STAGE 1 ROAD SAFETY AUDIT
Proposed Controlled Crossing Facilities
Marcham Road and Ock Street, Abingdon

Prepared for: Vale of White Horse District Council
Issue 1: 21 March 2014
Ref: TR8140418/GT/001

Figure 1

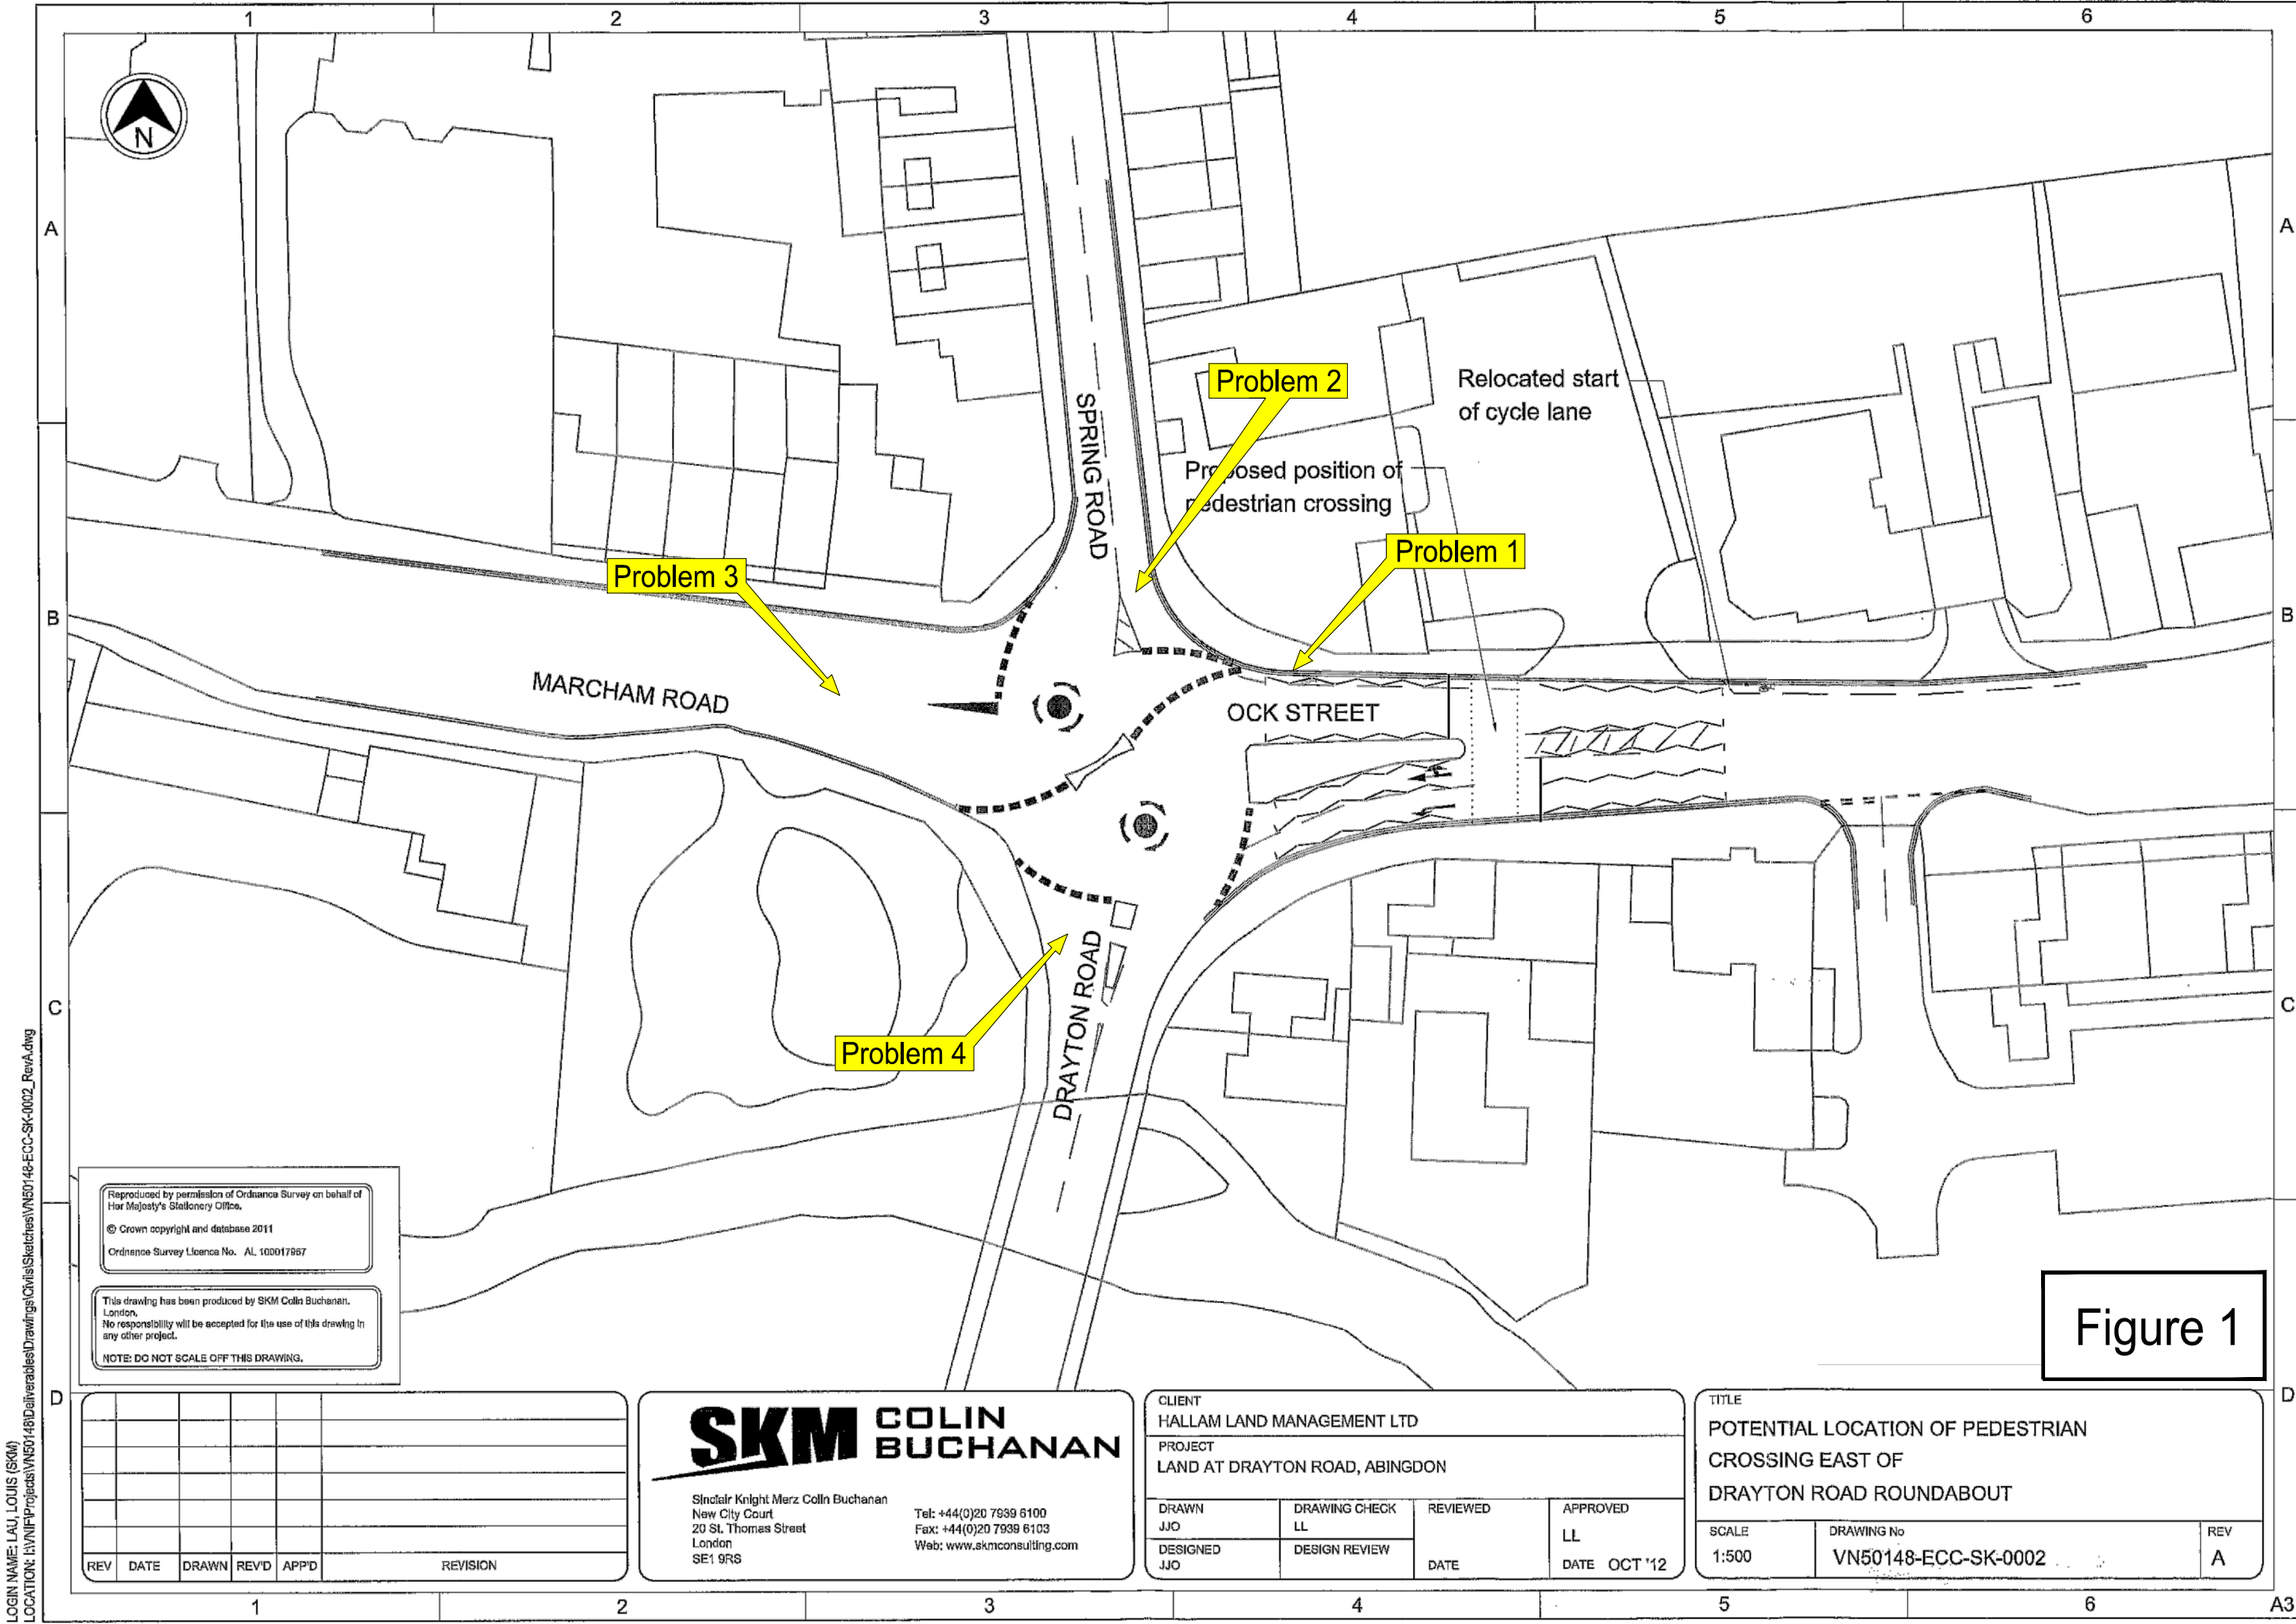
3.1 Problem 1

Location: East side of double mini-roundabout junction.

Summary: Pedestrians crossing away from signalled facility leading to risk of pedestrian / vehicle collisions involving personal injury occurring.

The signalled crossing facility, re-sited east of the junction, requires pedestrians walking between Drayton Road and Spring Road to use the east side of both roads, which, for the majority, departs from their natural desire line on the west side. There is concern that, rather than divert even further to use the signalled crossing facility, significant numbers of such pedestrians will attempt to cross Ock Street on the direct desire line via the central splitter island.

3.2 Problem 2

Location: North side of double mini-roundabout

Summary: Increased use of uncontrolled crossing facility across Spring Road near the junction, with poor visibility and insufficient footway width, leading to increased risk of pedestrian / vehicle collisions involving personal injury occurring.

Southbound pedestrians on west side of Spring Road will need to choose between significant diversion from desire line to the west to reach the signalled crossing facility re-sited further west or the new signalled crossing facility to the east. Those choosing to divert to the east first need to cross Spring Road. Most northbound pedestrians who crossed Ock Street will also need to cross Spring Road. This in itself introduces risk wherever crossing is attempted, but there is additional risk associated with poor visibility and insufficient footway width if crossing is attempted at the junction.

3.3 Problem 3

Location: West side of double mini-roundabout

Summary: Pedestrians crossing away from signalled facility leading to risk of pedestrian / vehicle collisions involving personal injury occurring.

The signalled crossing facility, re-sited west of the junction, requires pedestrians crossing between Drayton Road and Spring Road on the west side of both roads to divert significantly from their natural desire line to use the re-sited signalled crossing. There is concern that, rather than divert, significant numbers of such pedestrians will attempt to cross Marcham Road closer to the desire line, broadly where the existing crossing to be removed is located, leading to increased risk of pedestrian / vehicle collisions involving personal injury occurring. There is further concern that southbound pedestrians may attempt to cross at a point where there is pedestrian guardrailing on the opposite side, effectively trapping pedestrians within the carriageway exposed to traffic.

3.4 Problem 4

Location: South side of double mini-roundabout

Summary: Increased use of uncontrolled crossing facility across Drayton Road near the junction, leading to increased risk of pedestrian / vehicle collisions involving personal injury occurring.

Northbound pedestrians on west side of Drayton Road will need to choose between significant diversion from desire line to the west to reach the signalled crossing facility re-sited further west or the new signalled crossing facility to the east. Those choosing to divert to the east first need to cross Drayton Road. Some southbound pedestrians who crossed Ock Street will also need to cross Drayton Road. This in itself introduces risk, more so if such crossing is attempted away from the formal controlled facility further south on Drayton Road or the uncontrolled facility at the junction.

Recommendation: The footway width is insufficient to allow pedestrian guardrailling to be provided.
Discourage pedestrians between Drayton Road and Spring Road from using the east side of by providing more attractive crossing provision on natural desire line on west side.

Recommendation: There is insufficient space to widen the footway close to the junction.
Notwithstanding sub-standard footway width, provide appropriate formal crossing facilities at a suitable location on Spring Road remote from the junction, or discourage pedestrians between Drayton Road and Spring Road from crossing to the east side of by providing more attractive crossing provision on natural desire line on west side.

Recommendation: Provision of pedestrian guardrailing on the north side is not recommended as to be effective this would need to extend as far as the crossing and commensurate extension of guardrailing on the south side would need to include a parking lay-by, rendering it unusable.

Discourage pedestrians between Drayton Road and Spring Road from crossing to the east side of by providing more attractive crossing provision on natural desire line on west side.

Recommendation: Discourage pedestrians walking between Drayton Road and Spring Road from crossing to the east side of by providing more attractive crossing provision of Marcham Road on natural desire line on west side.
